RE: Approval of Grading Permit GRAD 2019-09 "Smith Creek Development: Phase 2B" (Parcel 3, Partition Plat 2018-075; Tax Lot 052W13 00107); [Accela](#) record no. 971-19-000148-PLNG.

Following original submittal of the grading permit application on September 4, 2019, staff approves the permit with the following conditions:

SHEET  
**07**  
 OF  
**28**

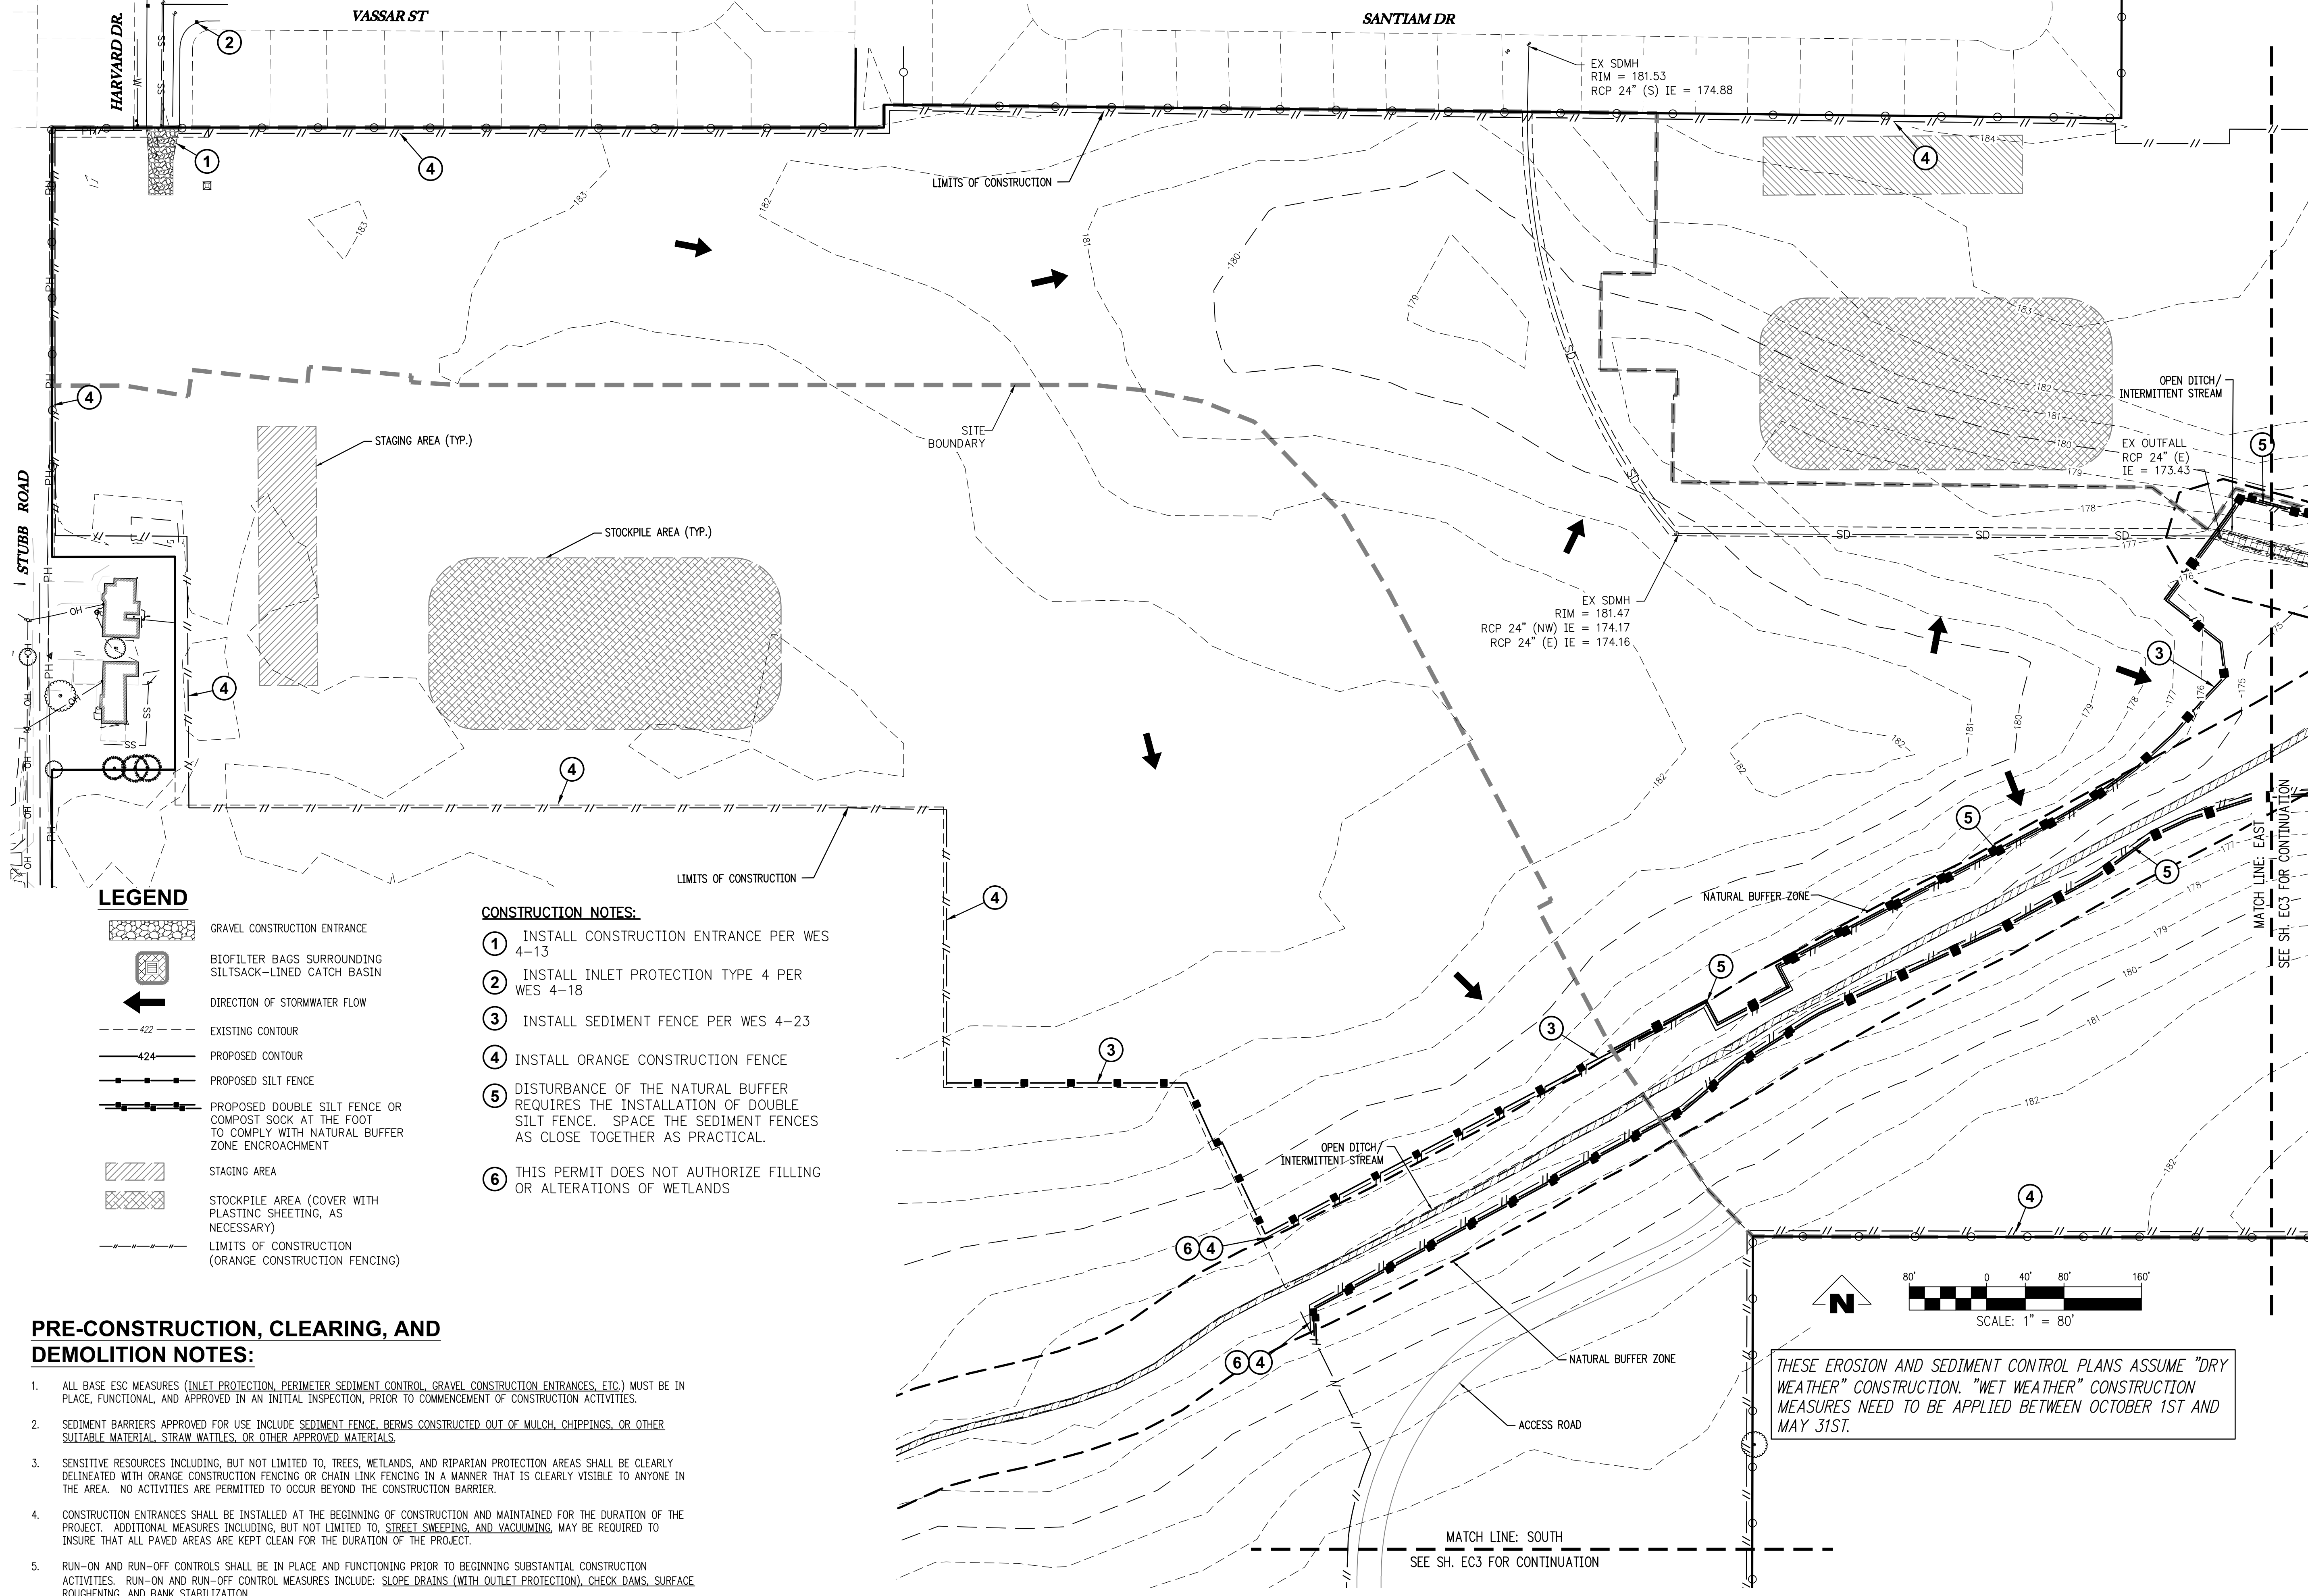
7. Comply with the submitted grading plan (Sheet 7) and erosion control plan sheets relevant to Phase 2B (Sheets EC1, 2, 4, 6 7); including measures to keep the ROW clean and to protect existing catch basins around the work area. All catch basins around the work area shall be clean of debris and soils at all times.
8. Continuously maintain adequate protection of all the work from damage and shall protect the public and private property of others from injury or loss arising in connection with the work.
9. Comply with City of Woodburn Planning Department requirements through [Woodburn Development Ordinance \(WDO\)](#) 5.01.04 Grading Permit.
10. Prior to starting work, contact the Public Works Department for inspection of the erosion control in the public ROW. Contact the Engineering Division at (503) 982-5240.
